DATE: May 17, 2023

RE: **Building Permit # B23001631**
8042 Old Montgomery
Ellicott City, MD 21784

8042 Old Montgomery Road
Ellicott city MD 21043

Horowitz Remodel

Date:	5/6/2023	Scale:	3/16" = 1' 0"
Sheet Name:	BASEMENT - EXISTING		
Sheet Number:	A-101		
2 of 7

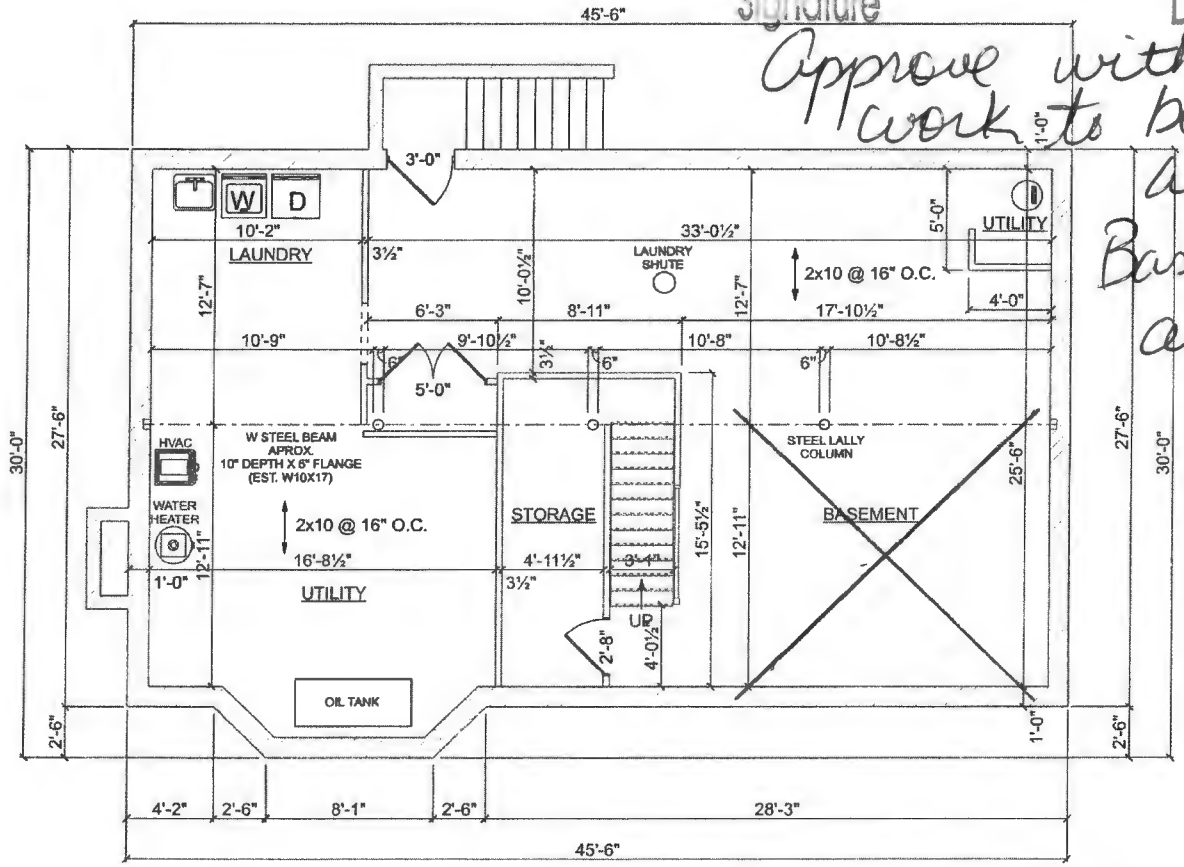
Approve with no work to be completed within

Basement Area.

Wye Home Designs, LLC Doug Gunn (410) 924-7856 dgunn@atlantictb.net		P.O. Box 95 Queenstown, MD 21658	
Horowitz Remodel			
Date: 5/16/2023	Scale: 3/16" = 1' 0"	© 2023 Wye Home Designs, LLC	
Sheet Name: BASEMENT - REMODEL		Sheet Number: 3 of 7

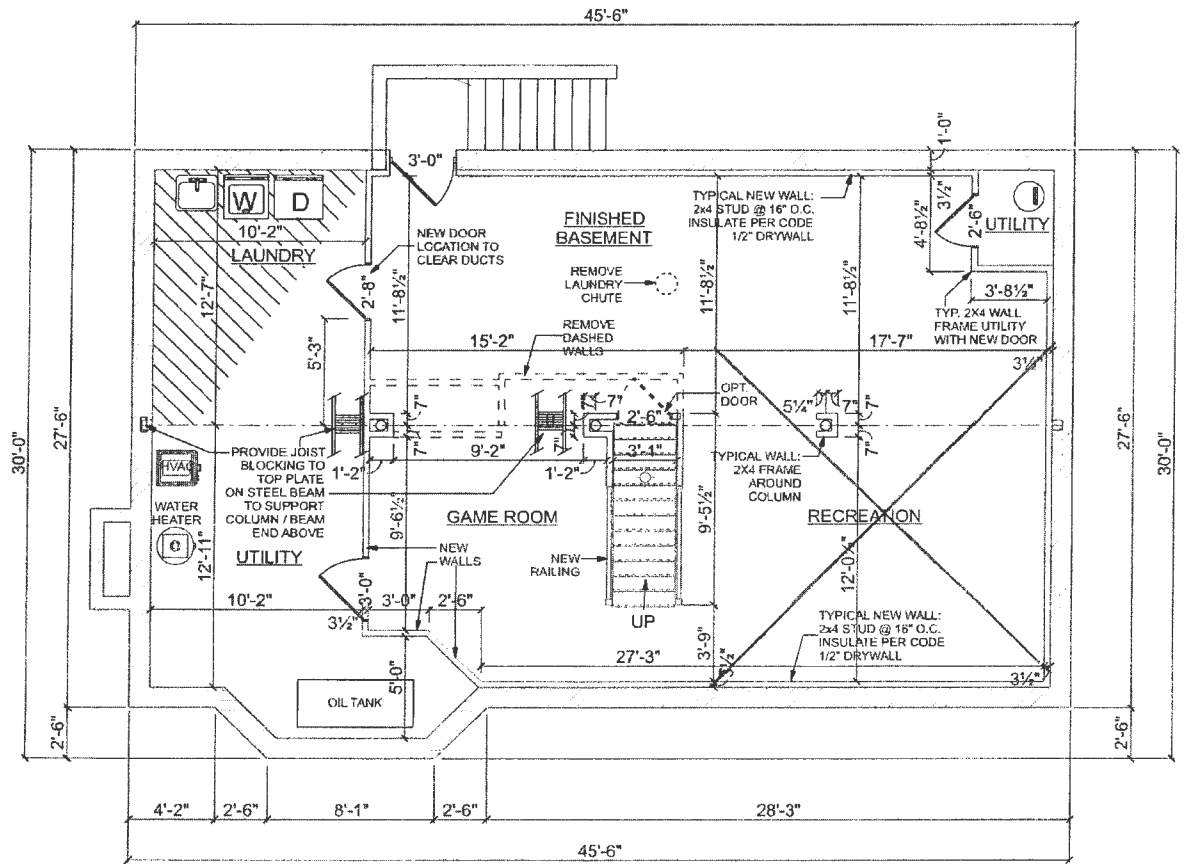
No work to be done in basement

No work to be done in basement
